**AIA**[®]**Document G701[™] – 2017****Change Order****PROJECT:** *(Name and address)*

Cecilia Valley Elem School

Date: October 29, 2018

To delete from Forbo direct purchase order, carpet and vinyl flooring in Reception 102, Workroom 103, First Aid 105, FRC 108, and Hall 110 per PR No. 5. Adding amount back to Isaac Tatum Construction's contract, previously deducted in Change Order No. 5 (see attached).

FLOOR FINISH REVISION @ ADMIN AREA, CASEWORK REVISION FRC 108

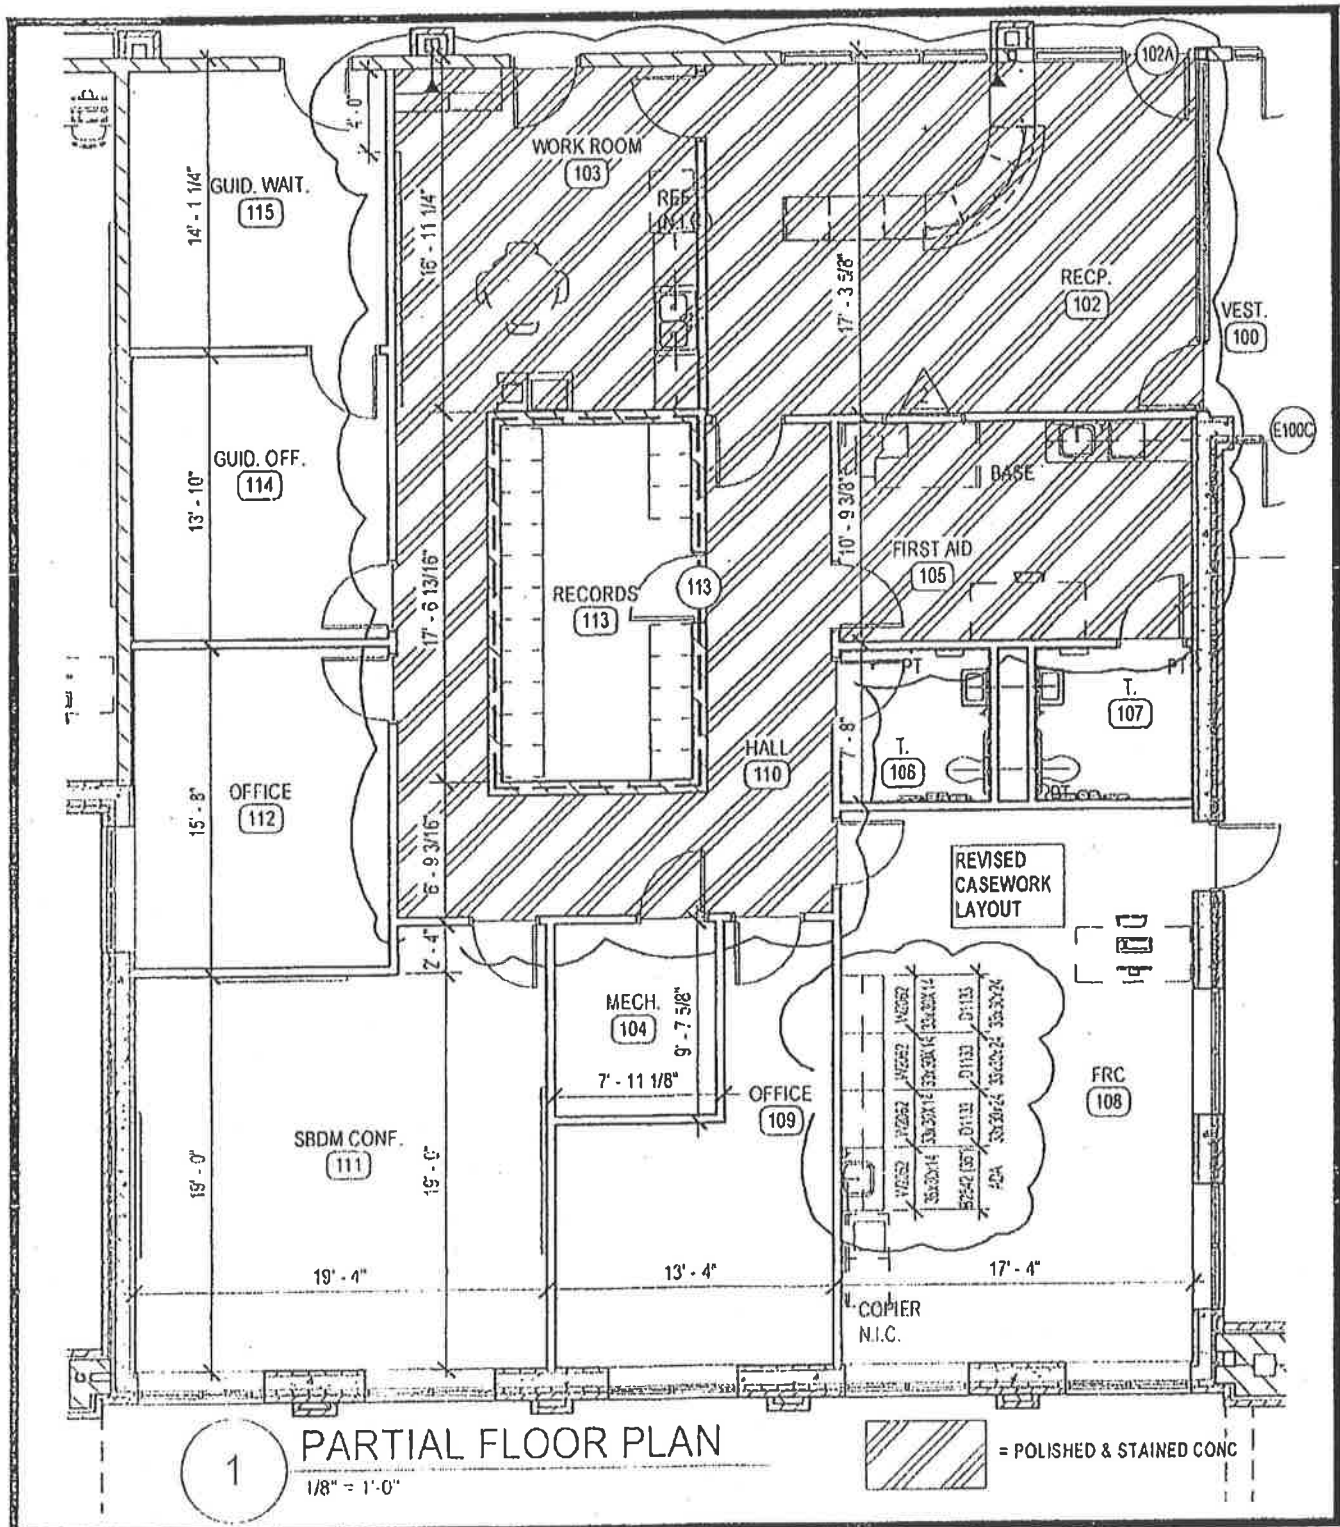
Omit linoleum flooring in Reception - 102, Work Room - 103 and First Aid 105. Omit carpet in FRC -- 108 and Hall -- 110. Within all rooms noted above, flooring to be polished, stained and sealed concrete.

Also, within FRC -- 108 omit 3 wardrobe units (12586). Provide base cabinets, wall cases and countertop. Refer to Drawing PR005-A

Replace 3 tall Cabinets with Wall/ base /top	\$0.00
Deduct for Linoleum(RMS 102,103,105)	-\$4,687.00
Deduct for Carpet(RMS 108,110)	-\$4,600.00
<u>Add for Polish concrete Unit Price</u>	
1545 Sq FT. @ \$3.85	\$5,948.25

Revise Linoleum Flooring to Stained Polish Concrete for
Reception-102, Work Room-103 & First Aid-105 DEDUCT \$4,687.00

Revise Carpet Flooring to Stained Polished Concrete for
FRC-108 & Corridor-110 DEDUCT \$4,600.00
